# Access Compliance Report

## Public Rights-of-Way

### (Curb Ramps)

Intersection ID: 10024247	Main Street: CPCC_HARRIS_CAMPUS_DR	Cross Street: N/A	Location: SE
ADA ID: 2D5453BC8A69	Ramp Type: ParaDiag	Initial Pass/Fail: Fail	Overall Compliance: No
			Severity Score: 13.75

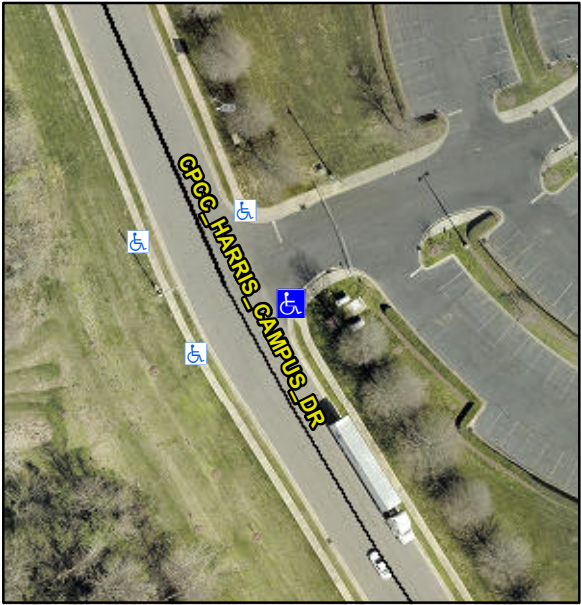
Codes/Mitigation Info/Possible Solution			Field Measurements/Component Compliance		
	Possible Solutions:		<b>Compliance</b>	<b>Description</b>	<b>Data</b>
	<b>Remove &amp; Replace Curb Ramp With Two New Directional Ramps or Equivalent.</b>		<b>N/A</b>	Ramp Length LT (in)	<b>48.0</b>
			<b>Yes</b>	Ramp Width LT (in)	<b>58.0</b>
			<b>No</b>	Ramp Slope LT (%)	<b>10.3</b>
			<b>Yes</b>	Ramp XSlope LT (%)	<b>1.1</b>
			<b>N/A</b>	Landing Length (in)	<b>N/A</b>
			<b>N/A</b>	Landing Width (in)	<b>N/A</b>
			<b>N/A</b>	Landing Slope (%)	<b>N/A</b>
			<b>N/A</b>	Landing X Slope (%)	<b>N/A</b>
			<b>N/A</b>	Landing Curb? (Y/N)	<b>N/A</b>
<p>Surveyor Notes:</p> <p><b>N/A</b></p> <p>PROW/ADA:</p> <p><b>R304.3.2, R304.5.3</b></p>			<b>N/A</b>	Ramp XSlope RT (%)	<b>4.1</b>
			<b>N/A</b>	DWS Provided?	<b>N/A</b>
			<b>N/A</b>	DWS Contrast?	<b>N/A</b>
			<b>N/A</b>	DWS Length (in)	<b>N/A</b>
			<b>N/A</b>	DWS Full Width?	<b>N/A</b>

<b>N/A</b>	DWS Offset (in)	<b>N/A</b>
			<b>N/A</b>	Gutter Slope (%)	<b>N/A</b>
			<b>N/A</b>	Gutter X Slope (%)	<b>N/A</b>
			<b>N/A</b>	Painted X Walk1?	<b>No</b>
			<b>N/A</b>	Painted X Walk2?	<b>No</b>
			<b>N/A</b>	X Walk 1 Direction	<b>To NW</b>
			<b>N/A</b>	X Walk 2 Direction	<b>To SW</b>
			<b>N/A</b>	X Walk 1 Width (in)	<b>N/A</b>
			<b>N/A</b>	X Walk 2 Width (in)	<b>N/A</b>
			<b>3.5</b>	X Walk 1 Slope (%)	<b>1.8</b>
			<b>1.5</b>	X Walk 2 Slope (%)	<b>5.0</b>
			<b>N/A</b>	X Walk 1 X Slope (%)	<b>N/A</b>
			<b>N/A</b>	X Walk 2 X Slope (%)	<b>N/A</b>
			<b>N/A</b>	Ramp inside XWalk1?	<b>N/A</b>
			<b>N/A</b>	Ramp inside XWalk2?	<b>N/A</b>
			<b>3.4</b>	Road Slope (%)	<b>N/A</b>
			<b>3.4</b>	Clear Space?	<b>N/A</b>
			<b>N/A</b>	Clear Space to XWalk (in)	<b>N/A</b>
			<b>N/A</b>	Storm Grate/Utility Hazard?	<b>N/A</b>
			<b>N/A</b>	Storm Grate/Utility Type	<b>N/A</b>
			<b>N/A</b>	Any Obstructions?	<b>N/A</b>

<b>N/A</b>	Obstruction Type	<b>N/A</b>
			<b>N/A</b>	Surface Condition? (G/P)	<b>Good</b>
			<b>N/A</b>	Curb Slope (%)	<b>8.6</b>
